Department of Energy
Washington, D.C. 20545

Docket No. 50-537
HQ:S:82:138

INSTRUMENTATION (CHAPTER 7) WORKING MEETINGS - ADDITIONAL INFORMATION

Instrumentation and Control (Chapter 7) September 21 and 22, 1982, and
November 18 and 19, 1982, Working Meetings Action Items Due to Nuclear
Regulatory Commission December 1, 1982

FIGURE 7.3-7
 FUNCTIONAL CONTROL DIAGRAM - ANNULUS
 FILTRATION SYSTEM, FILTRATION AND RECIRCULATION
 INITIATION

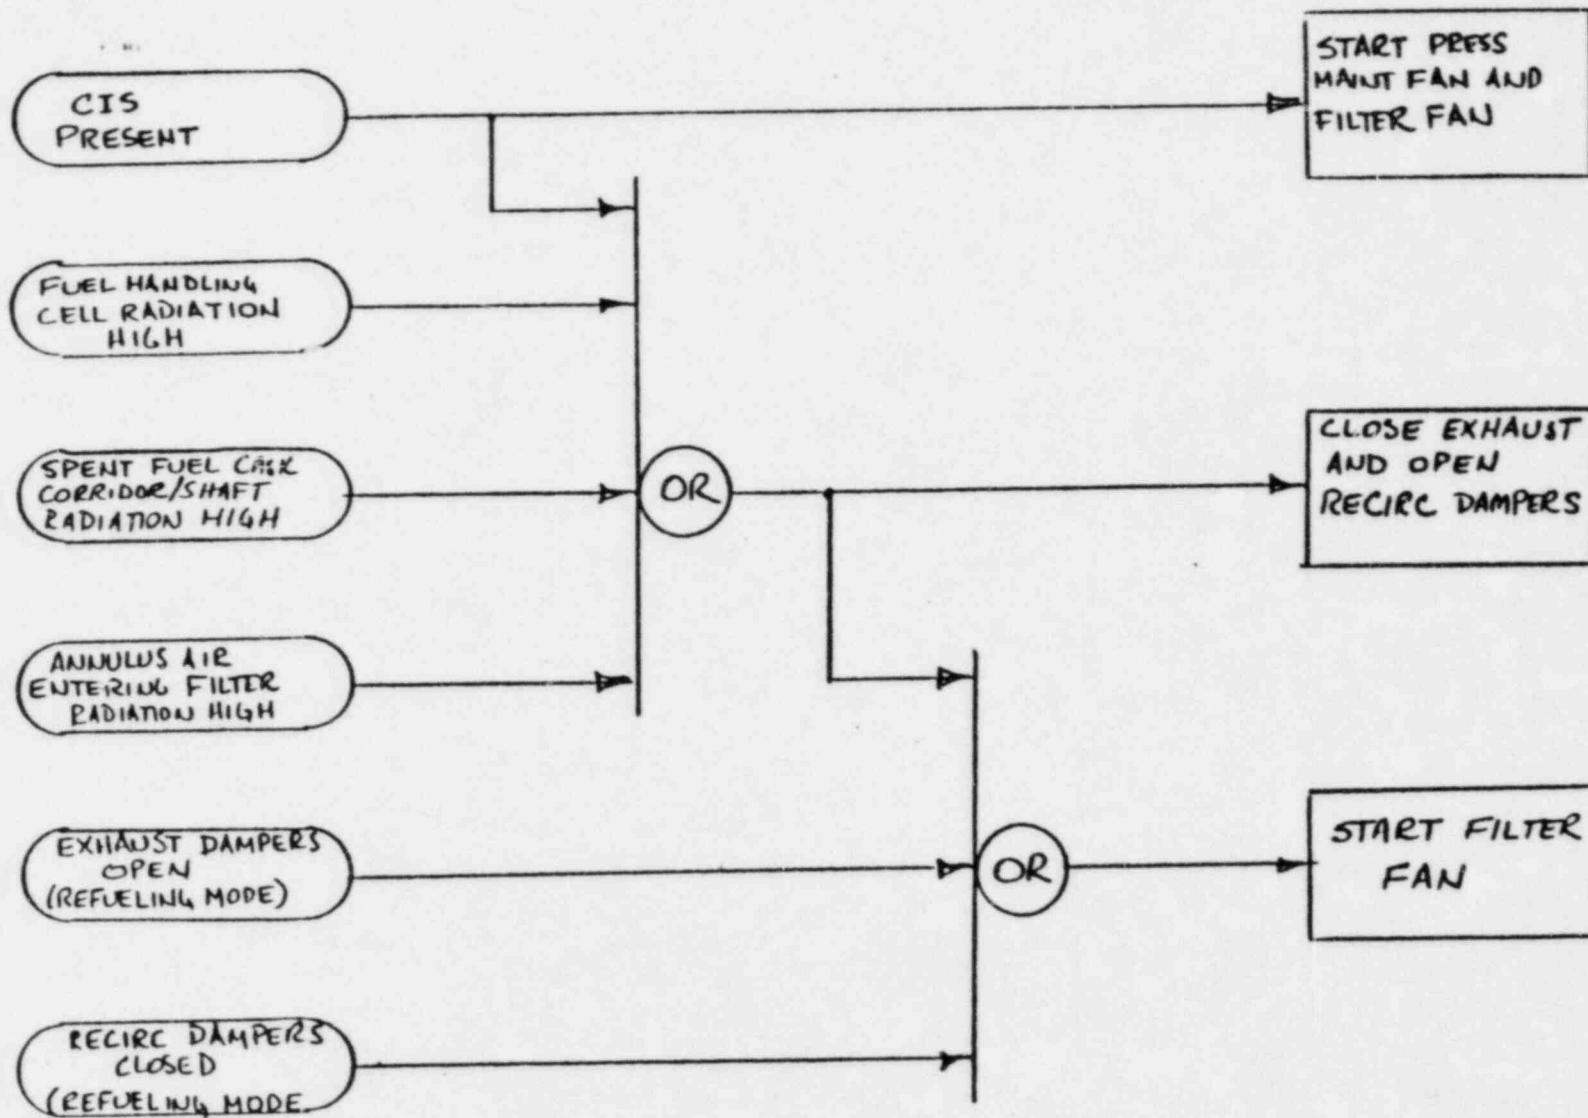
Initiation and control of the RCB Annulus Filtration System is represented by Figures 7.3-3 through 7.3-9. The following initiation and control operations shall be provided:

7.3-13
FIGURE 7.6-34 RSB FILTER FAN
FUNCTIONAL CONTROL DIAGRAM, TYPICAL INLET VANE MODULATION
~~PROCESS PARAMETER CONTROL OF DAMPER~~

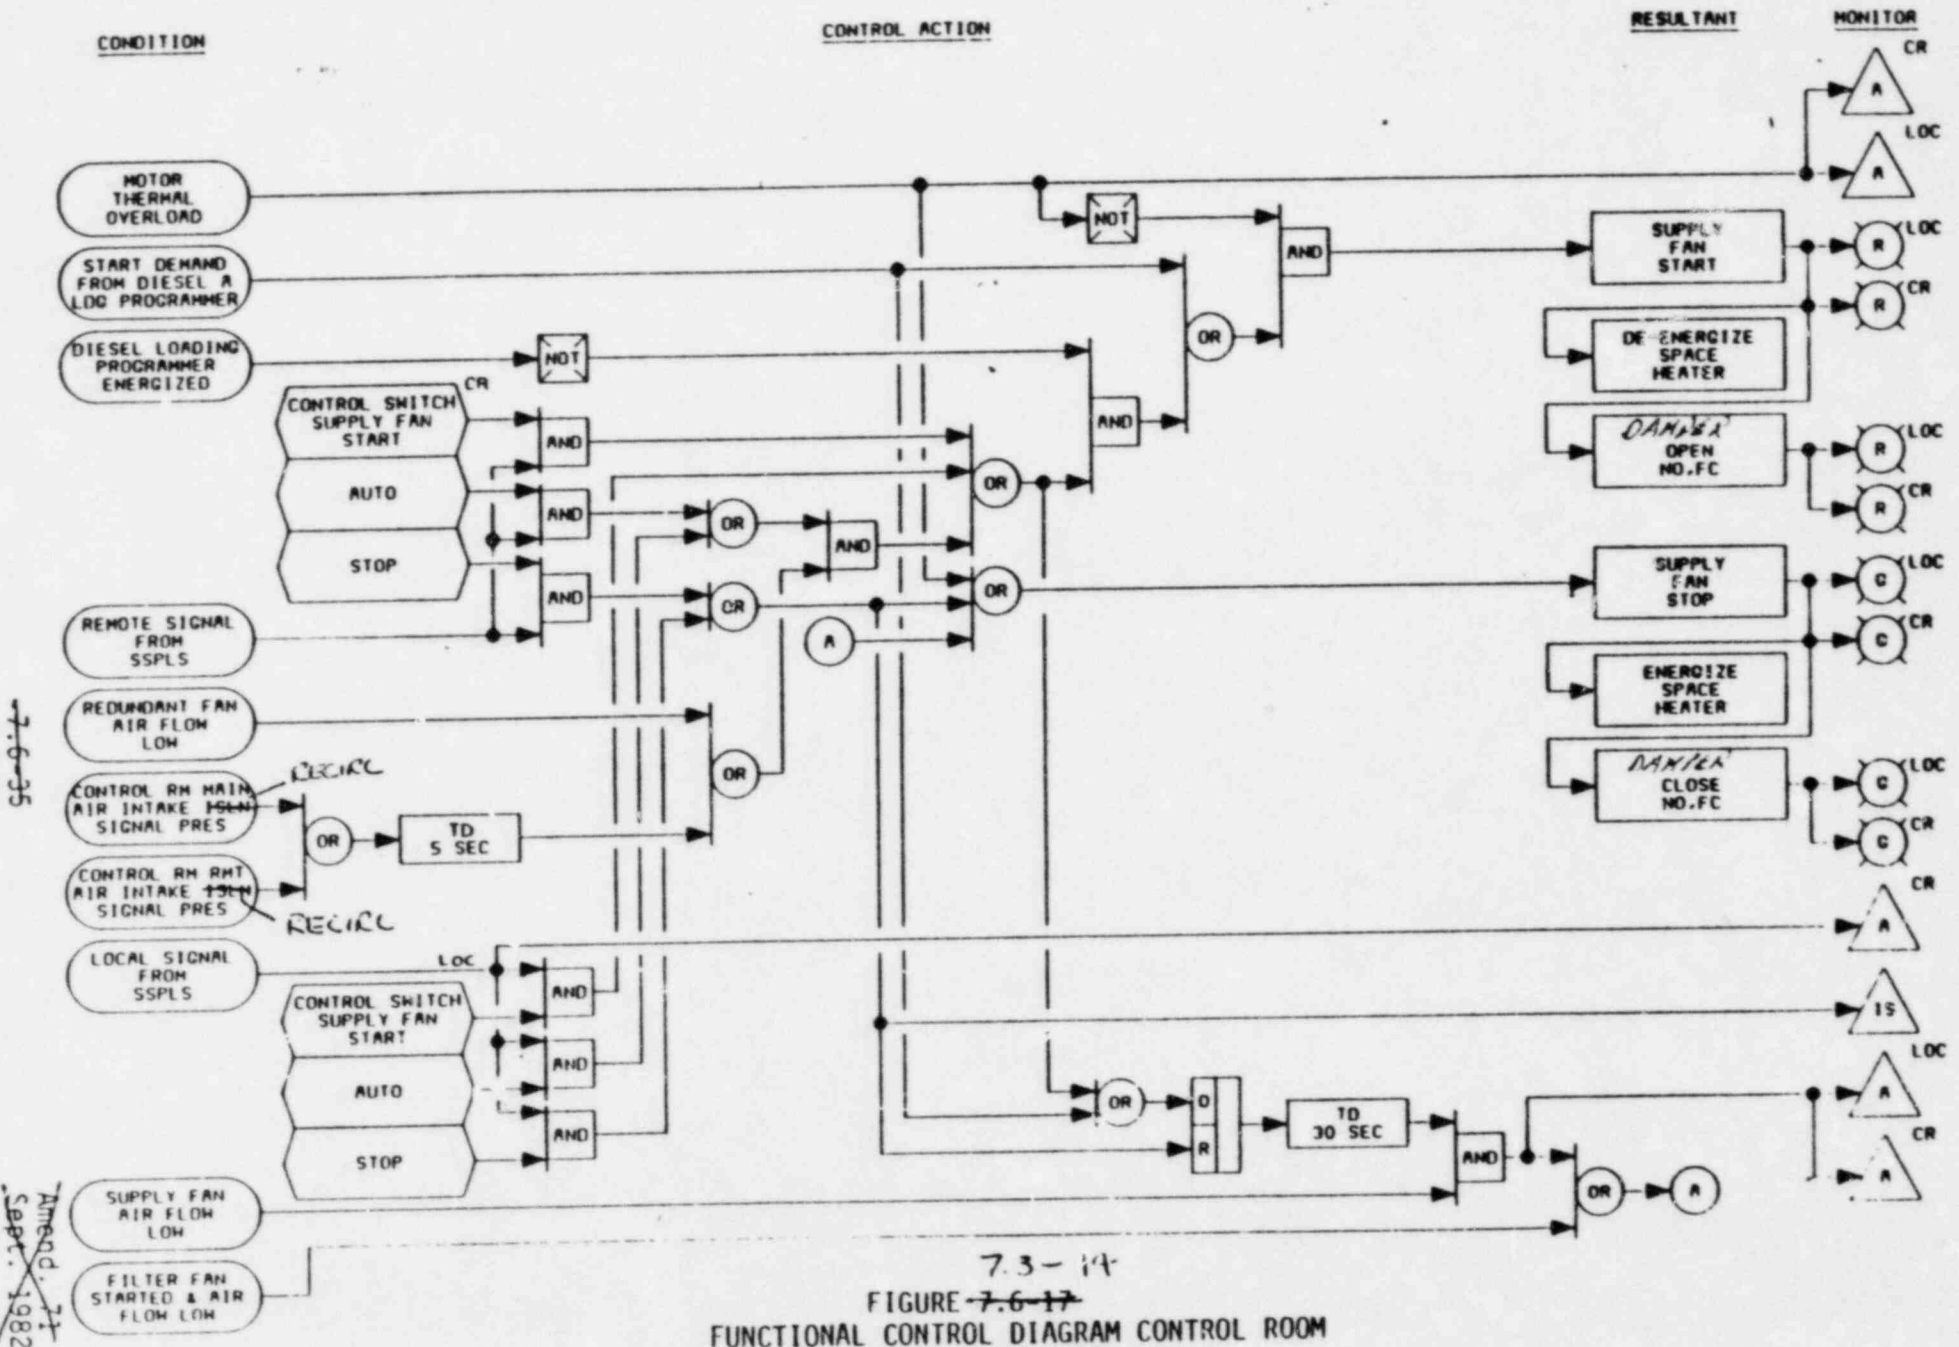
Initiation and control of the RSB Filtration System is represented by Figures 7.3-10 through 7.3-13. The following initiation and control operations shall be provided:

FIGURE ~~7.6-17~~
FUNCTIONAL CONTROL DIAGRAM CONTROL ROOM
HVAC UNIT SUPPLY FAN

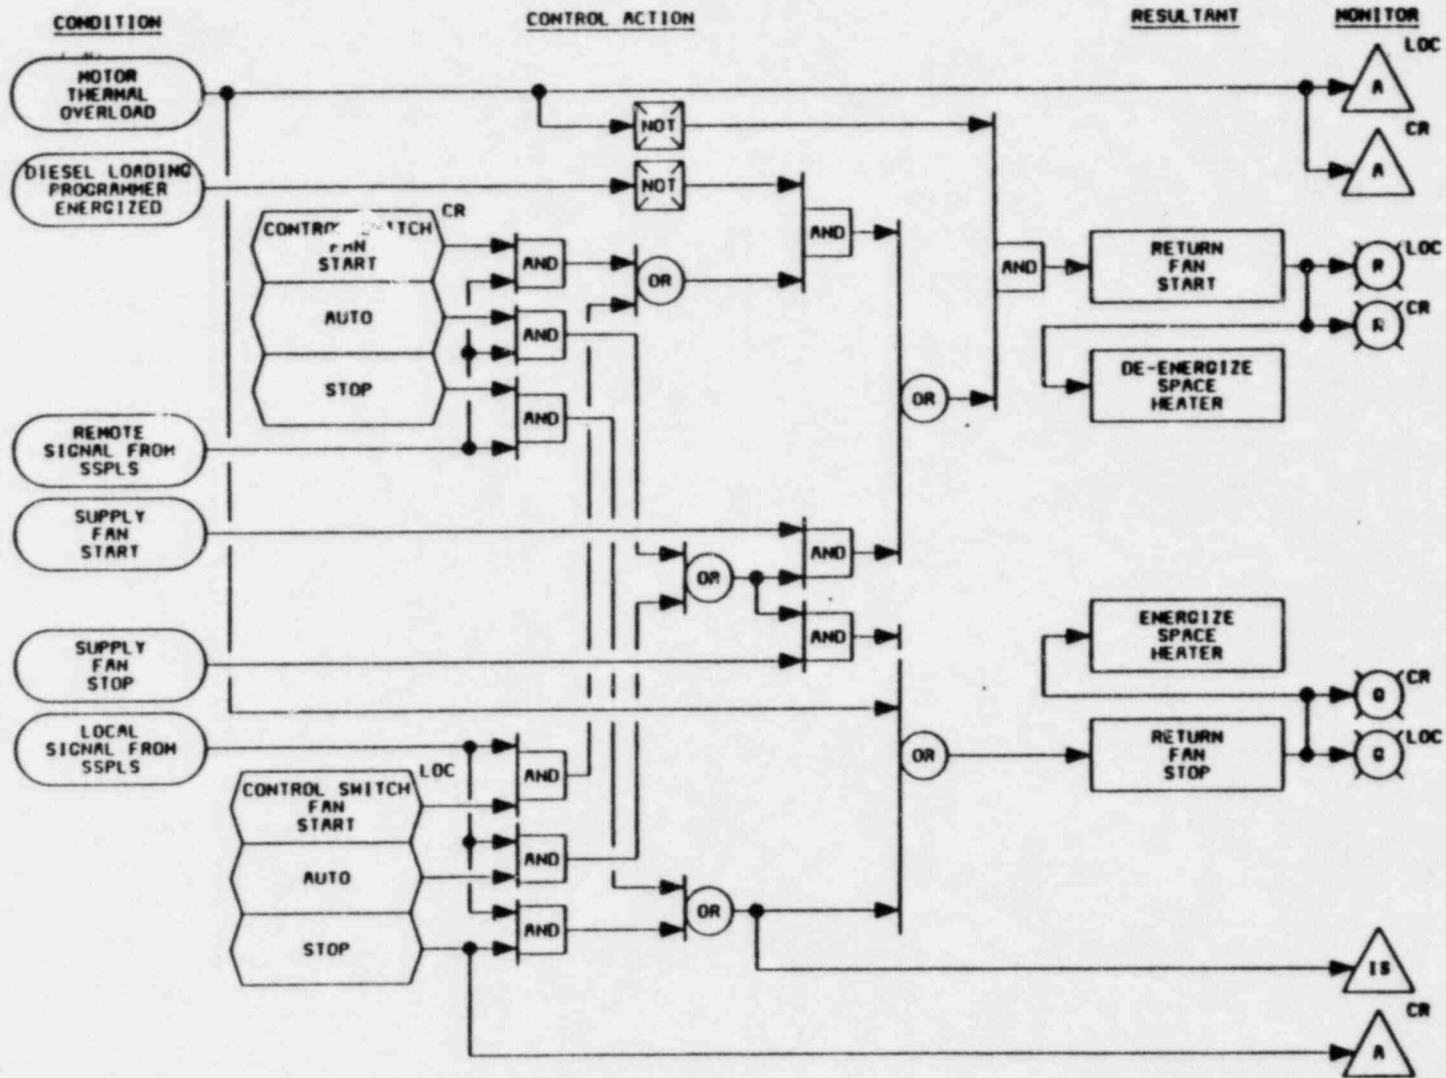
Figures 7.3-14 through 7.3-26²⁴ represent initiation and control of the Control Room Habitability System. A summary of the functions performed by this system is as follows:
